## SUNDRY NOTICES AND REPORTS ON WELLS

Yates Petroleum Corporation wishes to extend the captioned well's APD for two (2) years to September 13, 2011.  
H2S is not anticipated.  
C-102 Attached.  
Previously Approved.

# PECOS DISTRICT CONDITIONS OF APPROVAL

OPERATOR'S NAME:	YATES PETROLEUM
LEASE NO.:	NM-94614
WELL NAME & NO.:	2-CHECK BIC COM
SURFACE HOLE FOOTAGE:	660' FSL & 660' FWL
BOTTOM HOLE FOOTAGE:	' F L & ' F L
LOCATION:	Section 8, T. 19 S., R 31 E., NMPM
COUNTY:	Eddy County, New Mexico

Figure 1 – Cross Sections and Plans For Typical Road Sections

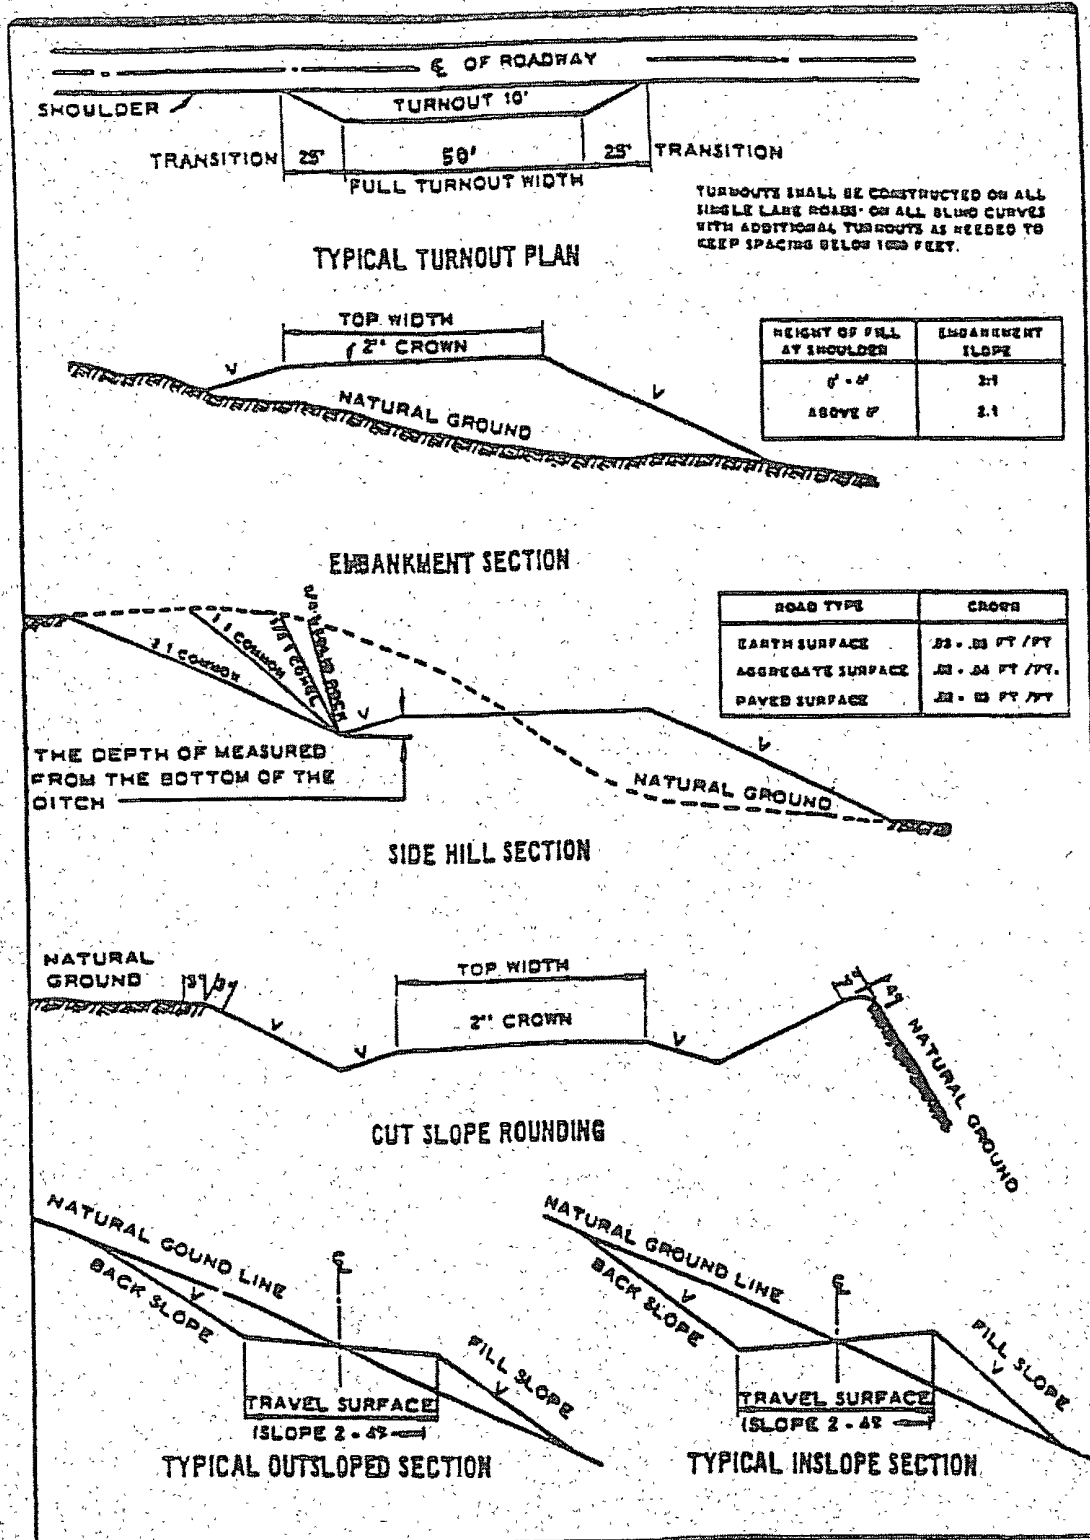
Crowning shall be done on the access road driving surface. The road crown shall have a grade of approximately 2% (i.e., a 1" crown on a 14' wide road). The road shall conform to Figure 1; cross section and plans for typical road construction.
